Attachment A

Response to Agency Submissions

A Response to Submissions (RTS) made by government agencies and other bodies to the public exhibition of SSDA 9536 is set out in detail below.

Figure 1 Master Plan – Southern Option
This image illustrates the proposed Southern redevelopment option.
Source: NSW Health Infrastructure

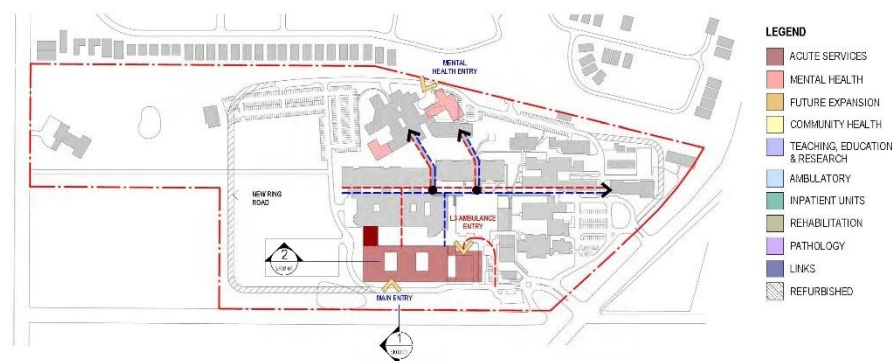
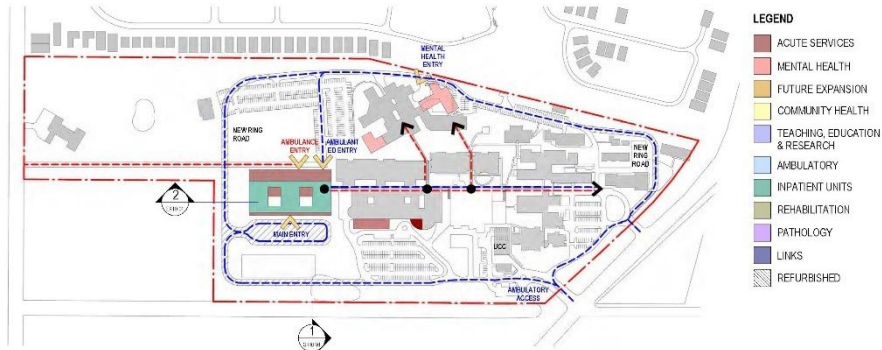
REF Approval	
<i>It is still unclear what works were approved and carried out in accordance with the</i>	<i>Car park approved to support ‘Southern Option’ redevelopment</i>

REF approval issued in late 2017. It was understood that the scope of the REF involved the preparation of a building pad for the proposed new hospital site. In this regard, the extent of tree removal is considered excessive.

As detailed at Sections 1.9 and 1.10 of the submitted EIS, a Review of Environmental Factors (REF) was approved by NSW Health Infrastructure in September 2017 under Part 5 of the Environmental Planning and Assessment Act 1979, which provided approval for the construction of an at grade car park with capacity for 566 spaces at the site. As a result of topography at the site, this car park was split into two sections (north and south). Construction then commenced in early 2018 for both sections of this car park and that construction of the northern portion of this car park has been recently completed and is operational.

At the time of the REF approval, the masterplan for site redevelopment provided for the proposed CSB at an alternate location, being the 'southern' option as detailed at Section 1.9 of the EIS. This 'southern option' redevelopment is generally located directly south of the existing main hospital building. Refer to **Figure 1** below.

As a result of the discovery of contamination at this locality, additional geotechnical testing was undertaken for the 'southern option' redevelopment. The results of the additional testing subsequently found that a risk of contamination for the 'southern option', being classified as high, and therefore not suitable as a location for the proposed redevelopment. Accordingly, due to a number of factors including the contamination risk, this 'southern option' redevelopment was subsequently abandoned.
